[EXTERNAL] PLN 20-0541—910 Centennial Ave.

Project Number:  
PLN20-0541 Project  
Address: 910  
Centennial Ave.

**Subject:—Design Review for 910 Centennial Avenue - -PLN20-0541 (to be considered by the Zoning Administrator on 4-19-21)**

Attachment: Photo of garage at east end of Centennial Avenue

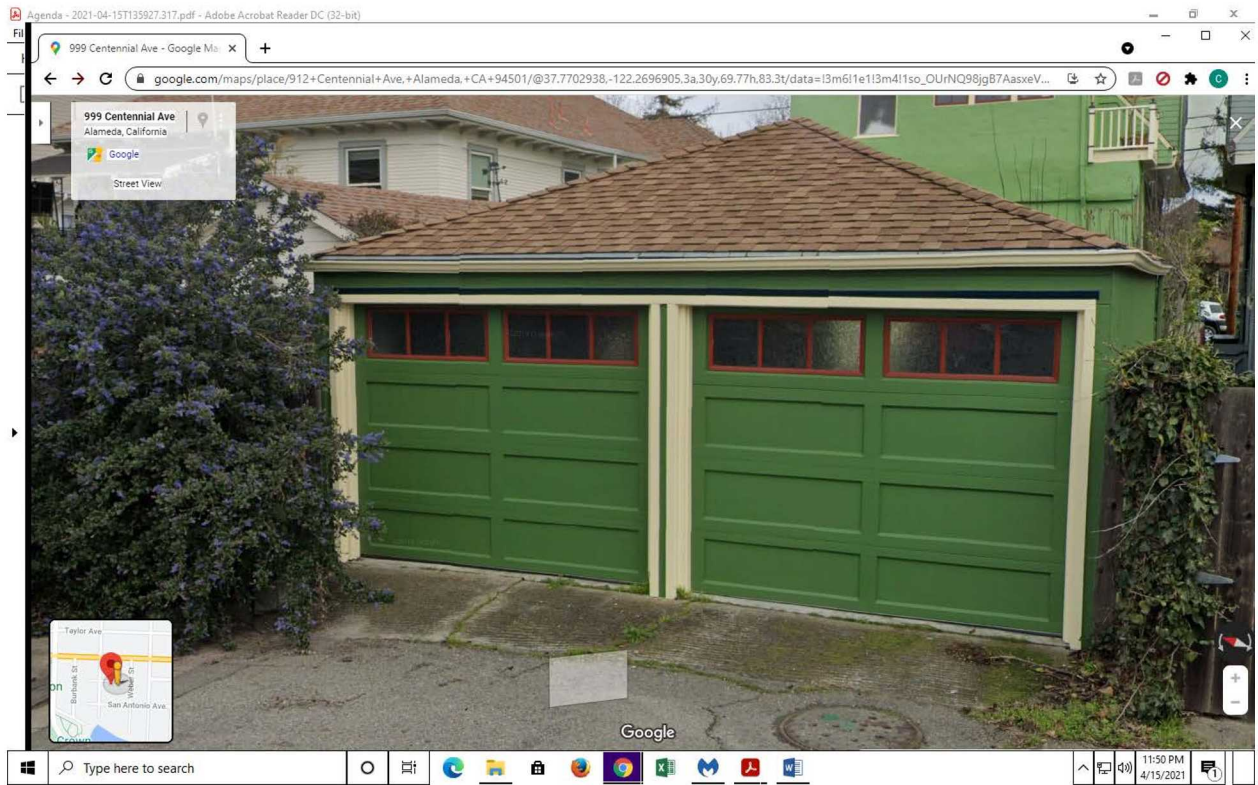
2. **Consider providing “paved tire tracks” instead of the proposed solid paved driveway as per Guide Provision (b) above.**
  3. **Consider providing a more “architectural treatment” of the garage doors.** Although most of the neighboring garage doors do not have what could be considered “architectural treatment” as per Guide Provision (c) above, such treatment should be seriously considered given the visual prominence of the garage. The doors of the nearby garage at the east end of Centennial Avenue are a good model. See attached photo.
